NEW ORLEANS TO VENICE, LOUISIANA  
DESIGN MEMORANDUM NO. 1 - GENERAL DESIGN  
SUPPLEMENT NO. 4

REACH B2  
FORT JACKSON TO VENICE

LMVED-TD (NOD 23 Aug 72) 1st Ind  
SUBJECT: New Orleans to Venice, Louisiana, Design Memorandum No. 1 -  
General Design, Supplement No. 4, Reach B2 - Fort Jackson  
to Venice

1. The subject design memorandum is forwarded for review pursuant to para 21a, ER 1110-2-1150. Approval is recommended subject to the following comments.

FILE NO. H-2-25953  
**PLATE 5**

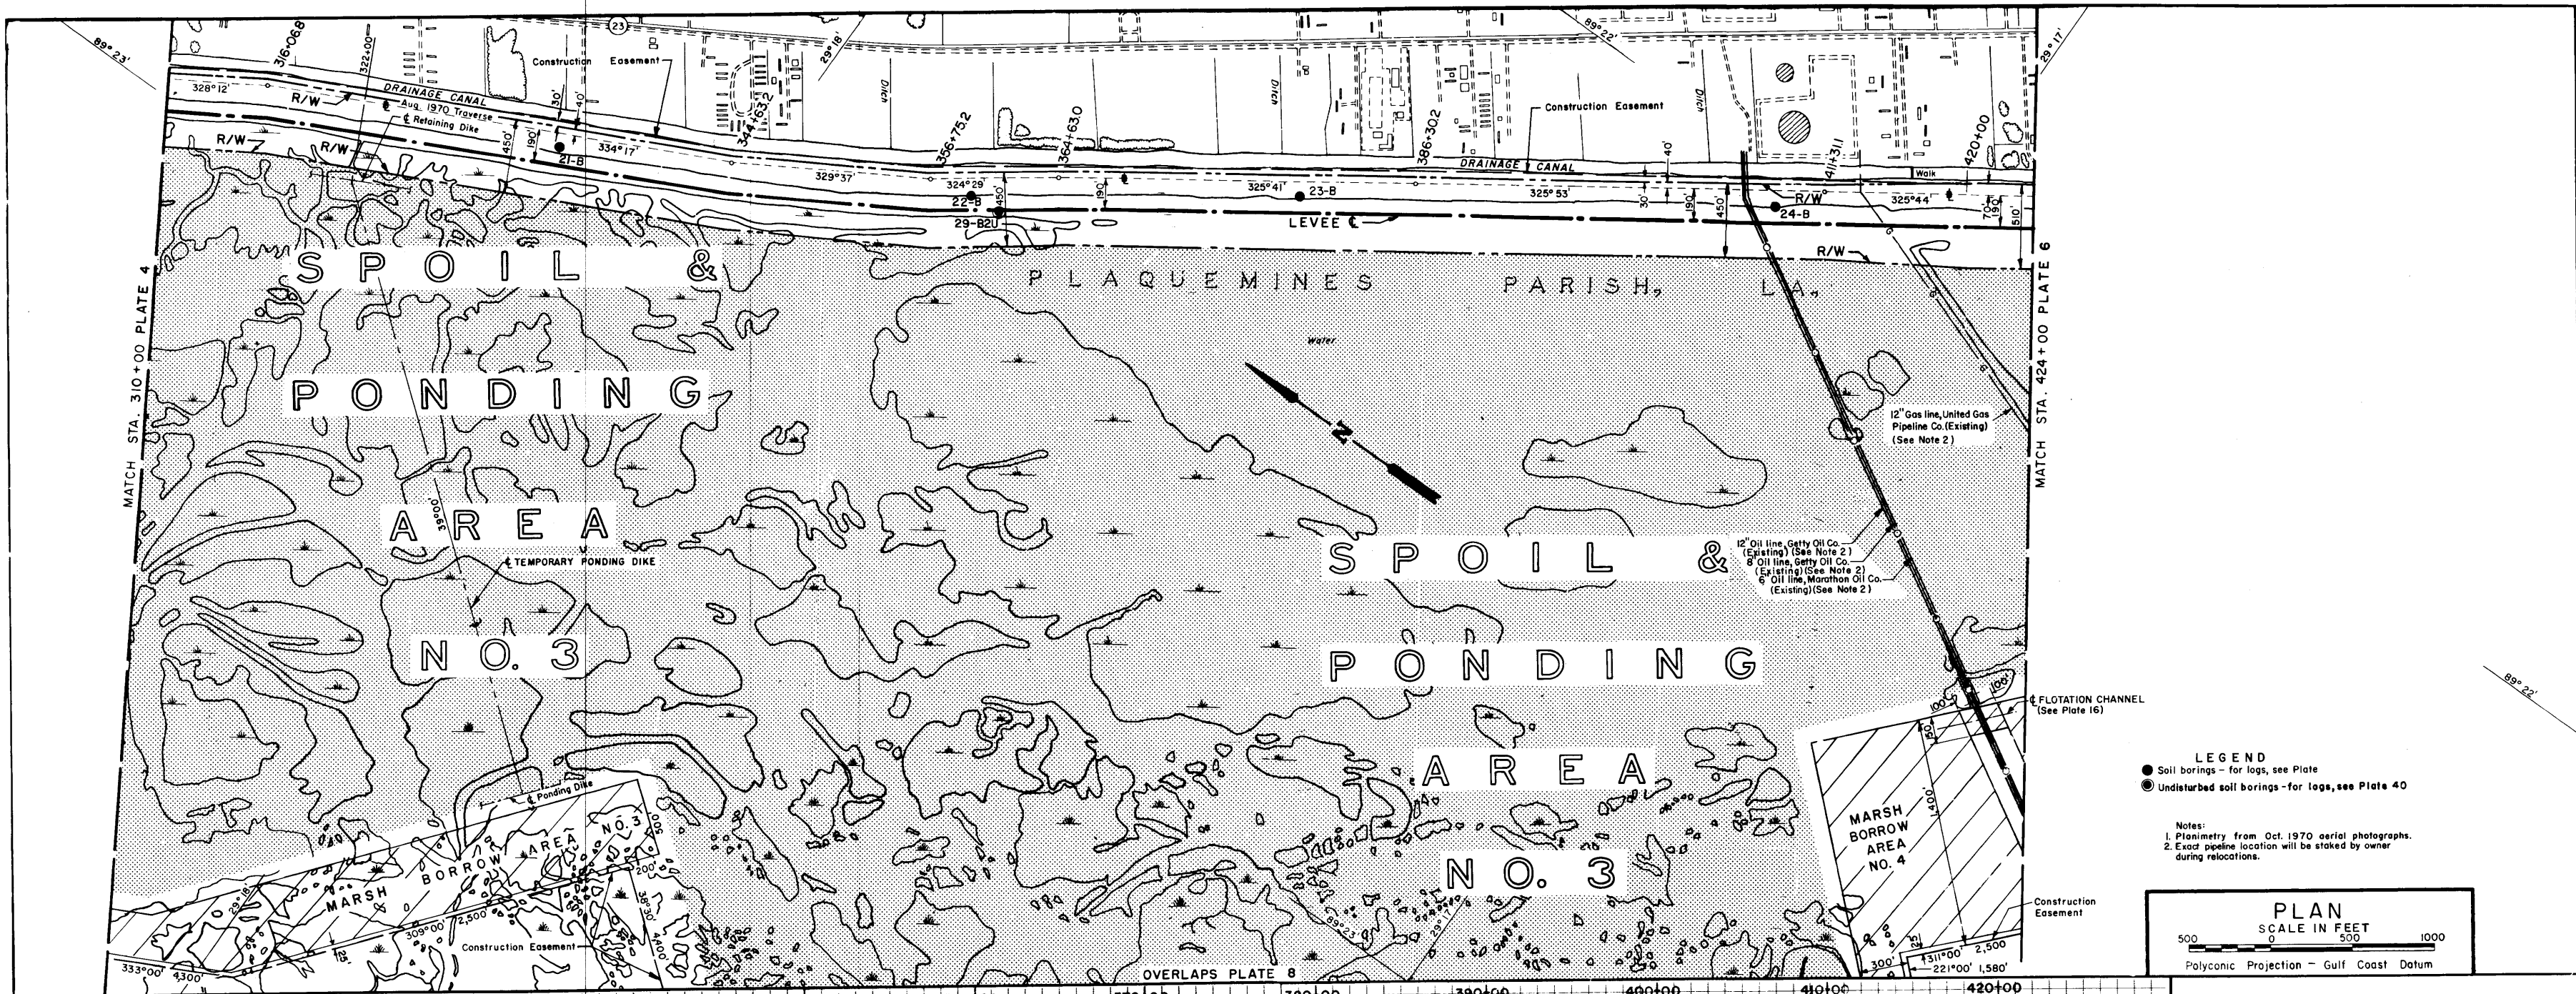
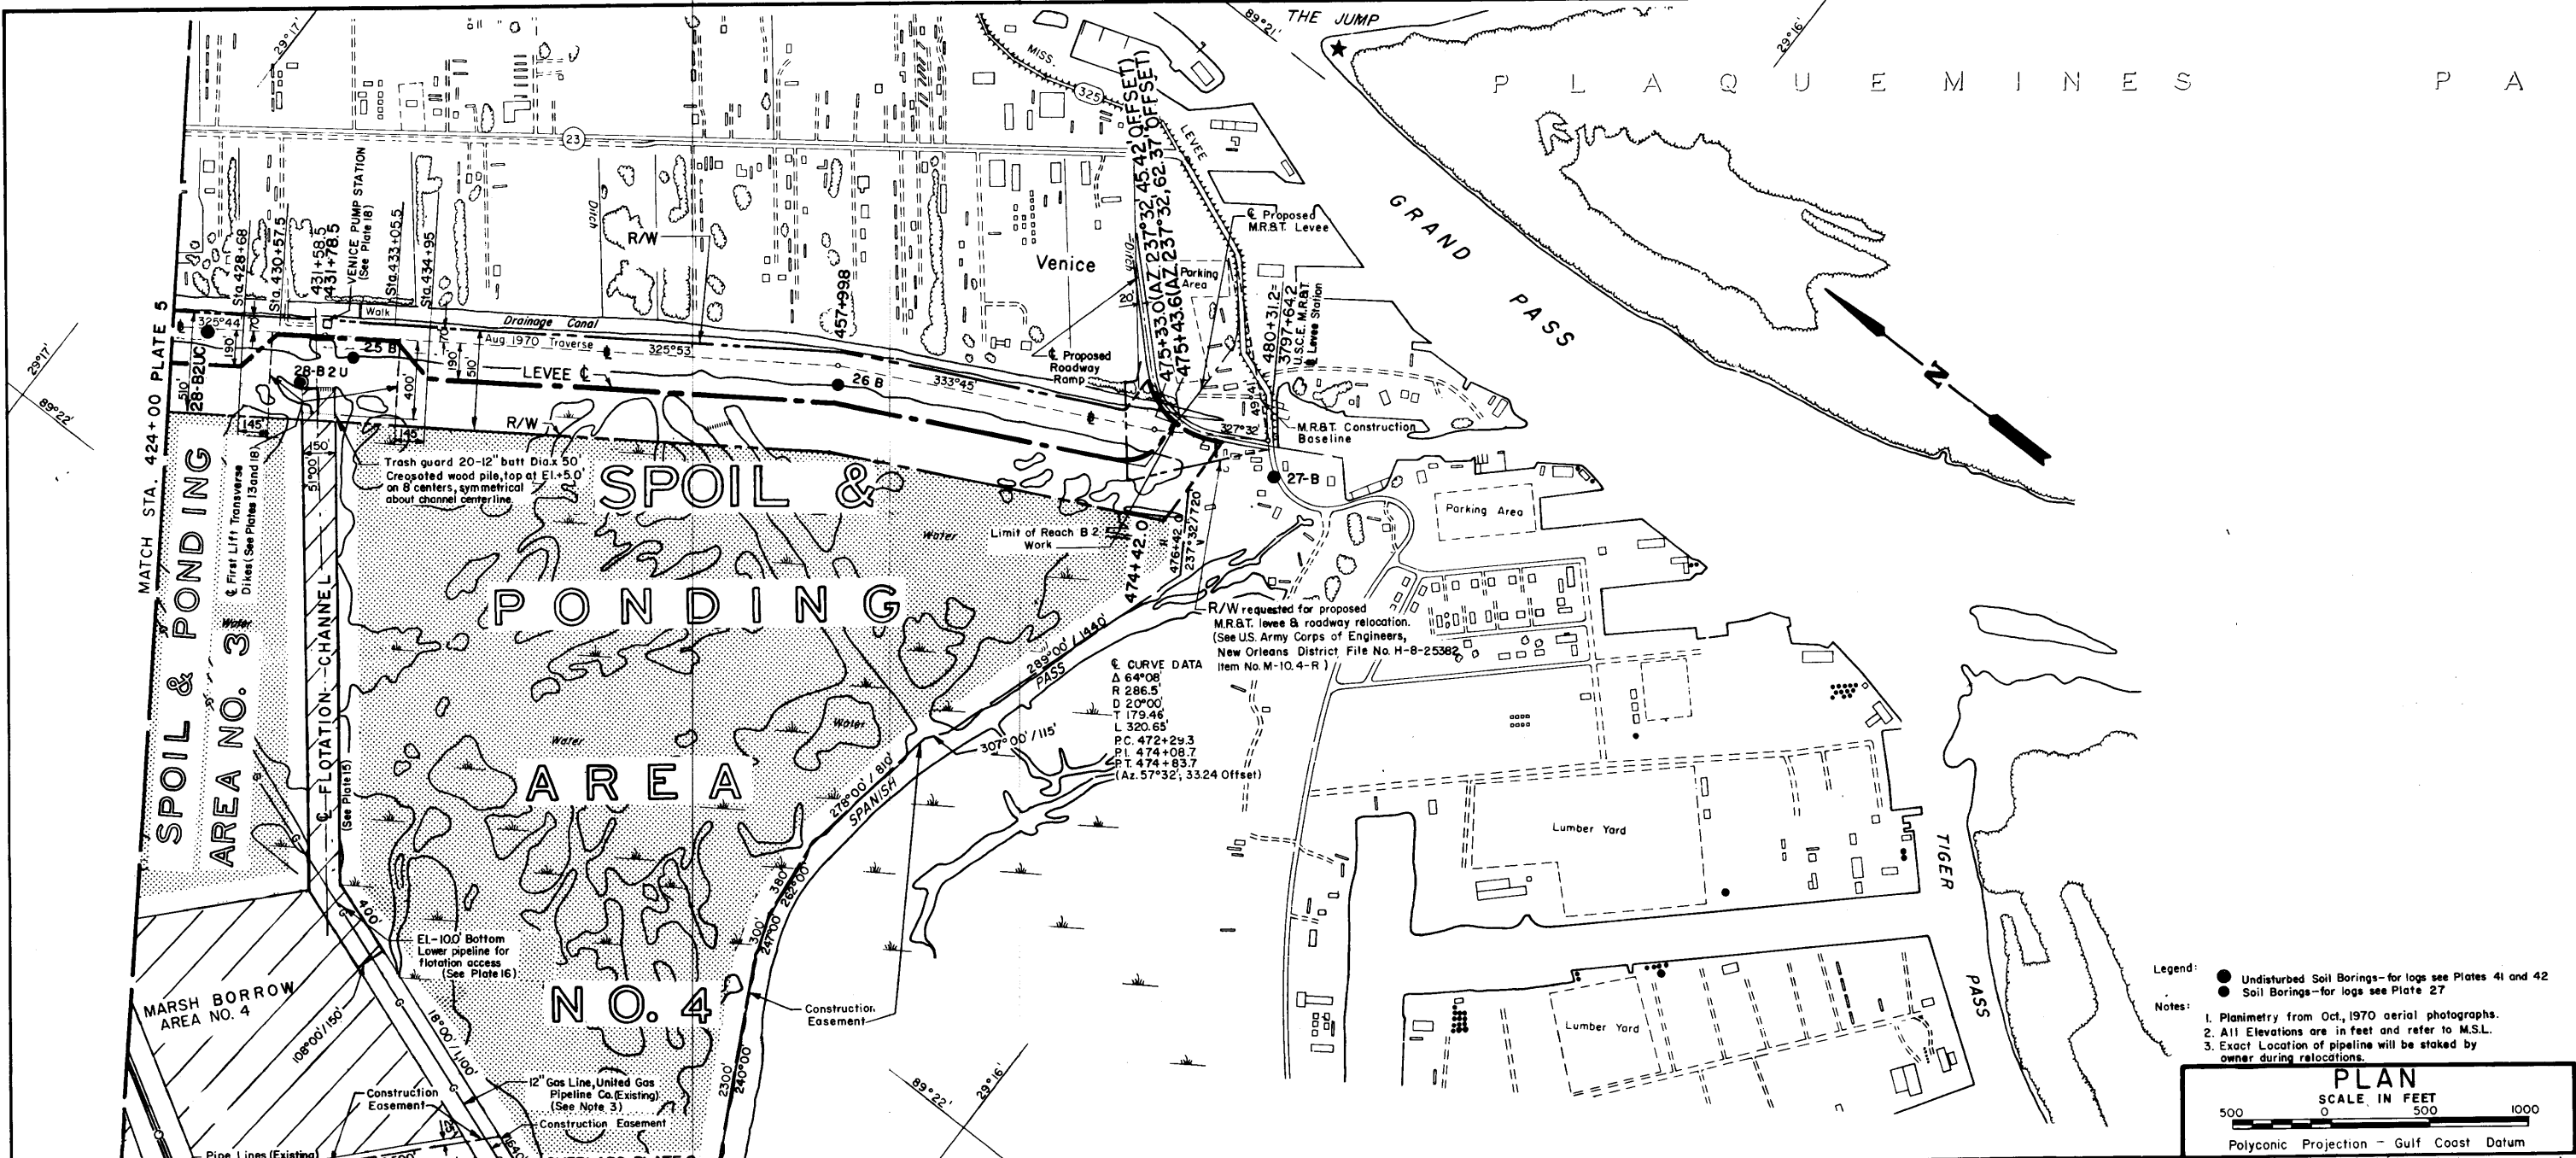
5. Para 41a, Page 24 and Plate 5. B/L stationing for the 6-inch oil line, and 12-inch United Gas Pipeline Co. line does not agree. These discrepancies should be resolved.
